PATHFINDER  
 COMMUNITY  
 CENTER  
 6655 STATE HWY 115,  
 FLORENCE, CO 81226

C2/10  
 SITE PLAN

## Pathfinder Community Center ADA/ICC A117.1 Accessibility Plan Review

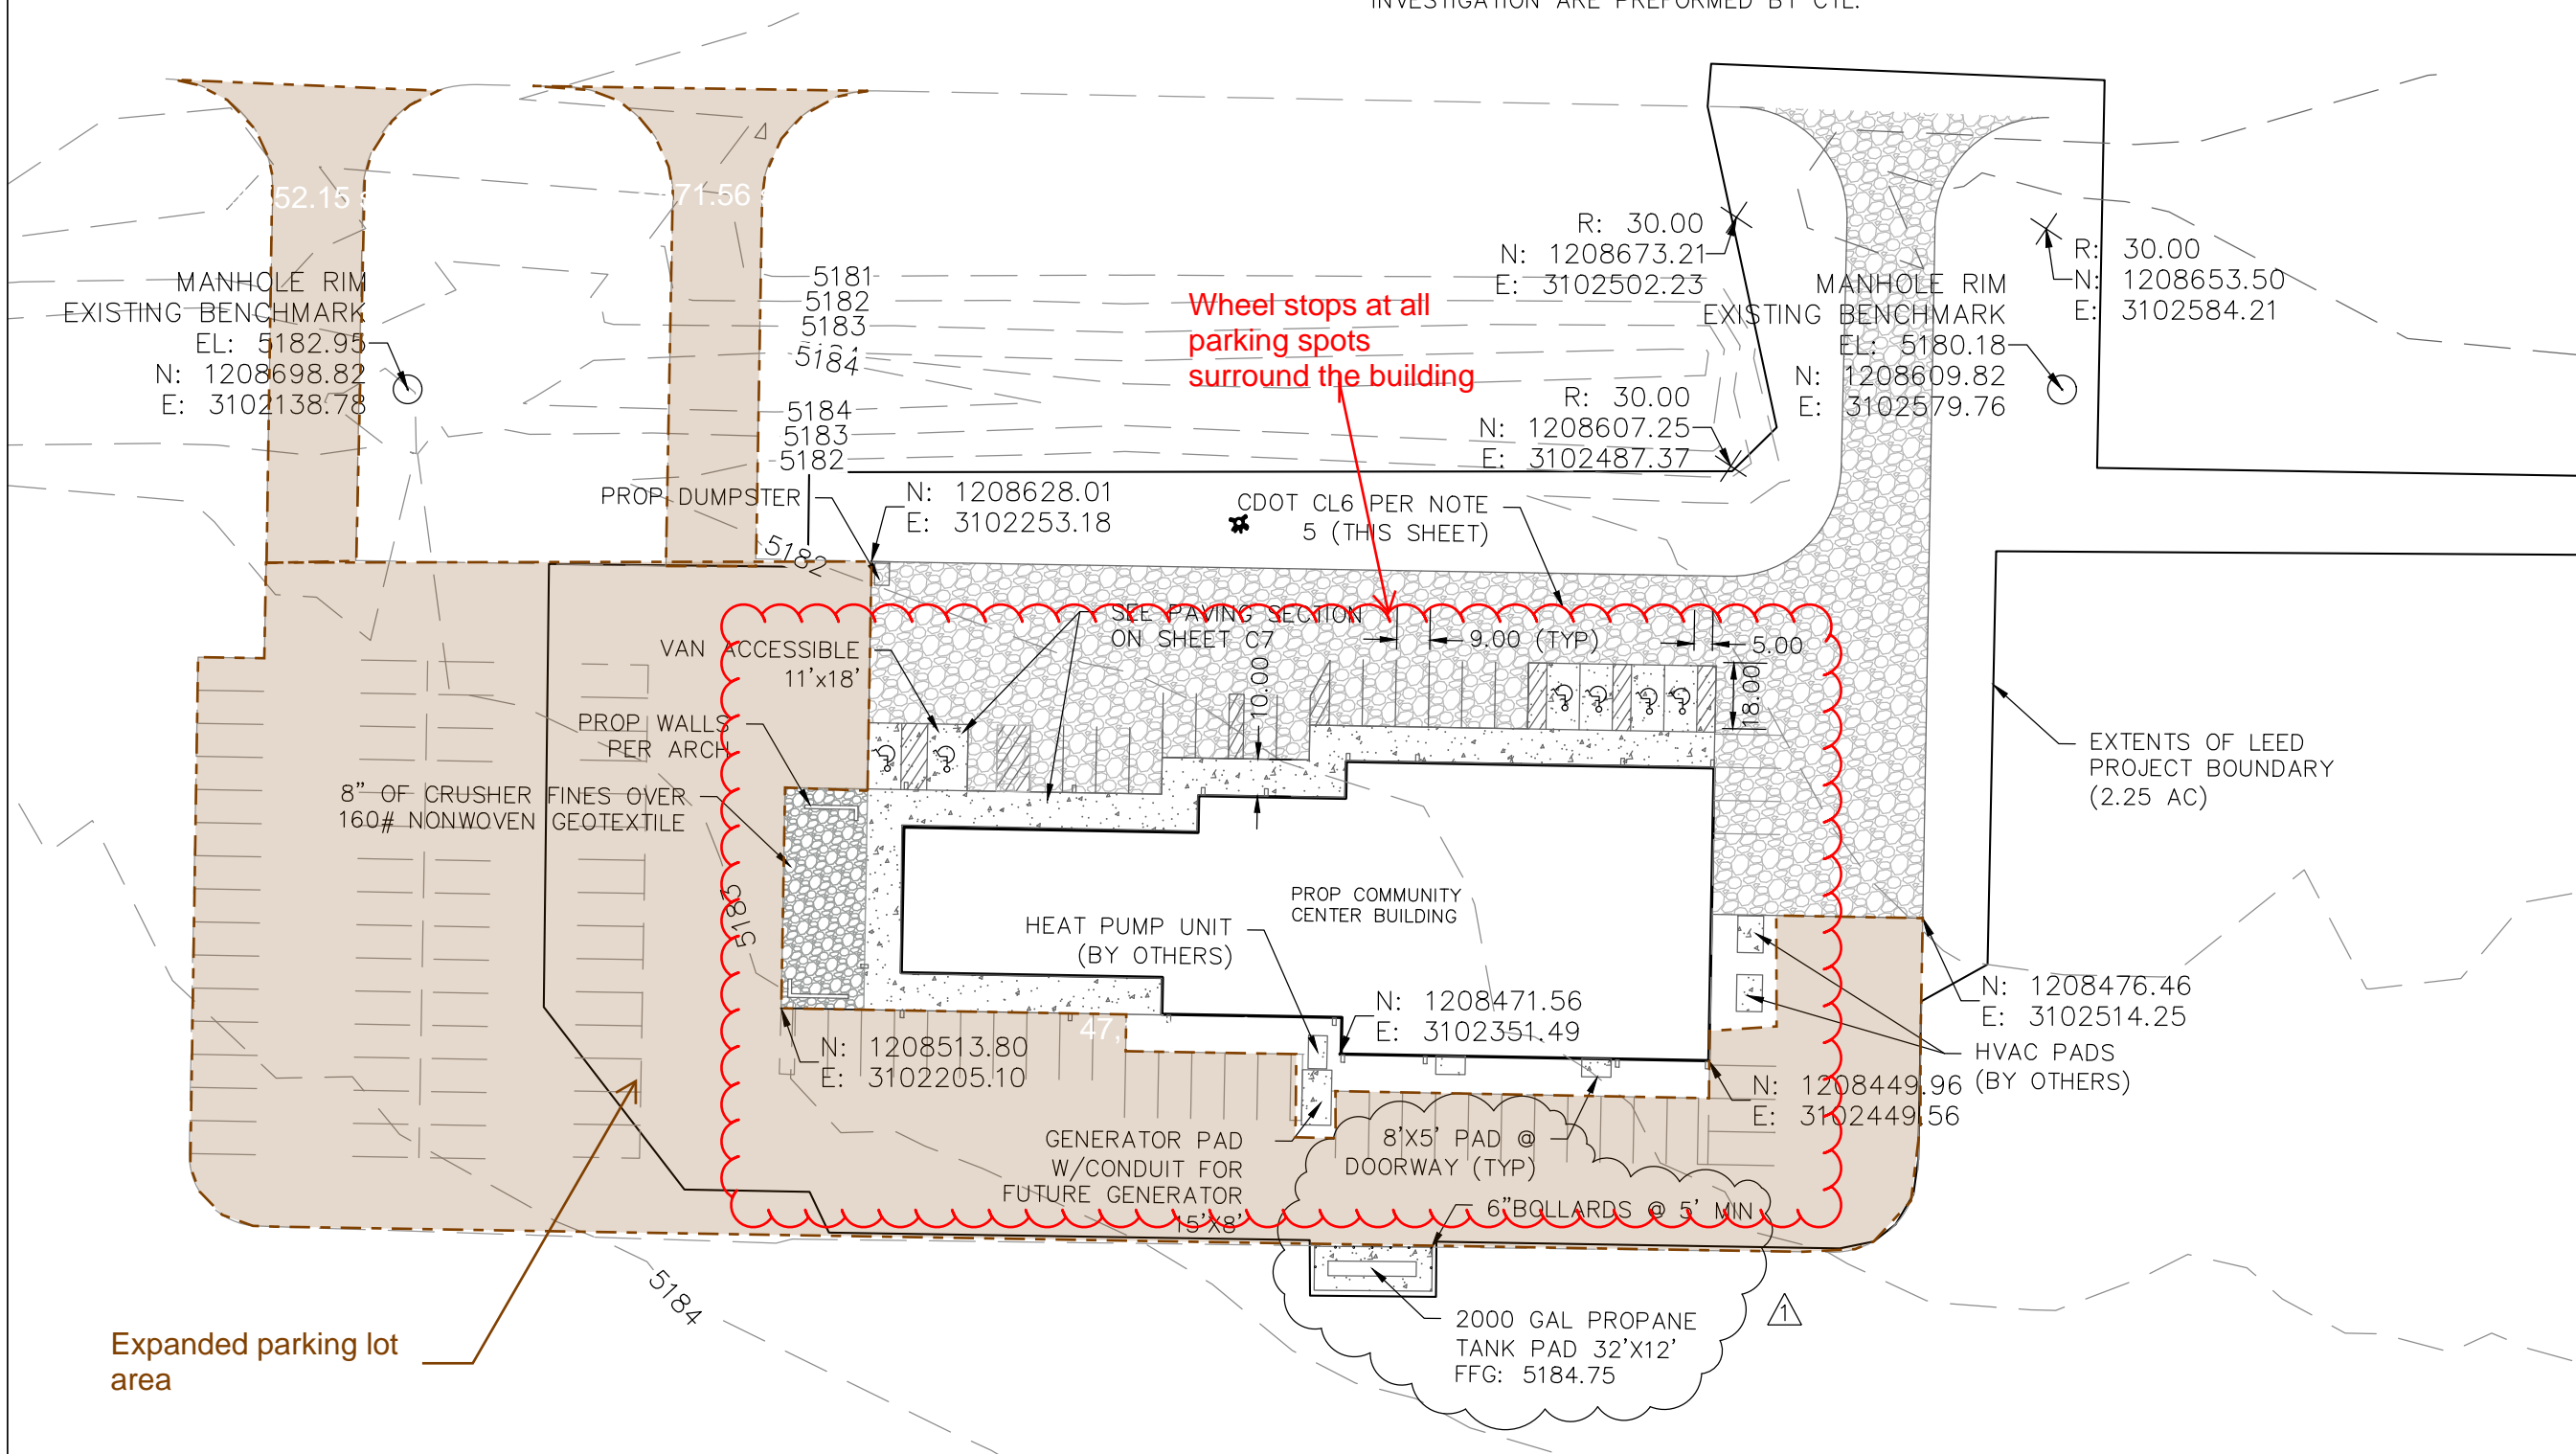
3) The parking appears to be at the same level as the sidewalk surrounding the building.

a) If this is the case, then wheel stops and/or bollards will need to be installed to protect the building and prevent the path of travel from the accessible parking spaces to an accessible entrance being blocked by vehicles parked right up against the building.

b) If this isn't the case, and there is a curb — then detailed curb ramp drawings should be provided — as incorrectly designed & installed curb ramps are a common architectural problem.

4) As drawn, the bike rack might block the accessible path of travel from the four accessible parking spaces to the restrooms, office, & meeting rooms. Therefore, I suggest rotating it 90 degree - just to make sure the accessible path of travel remains clear.

Parking Lot and Sidewalk  
at same elevation. Wheel  
stops included in this CO
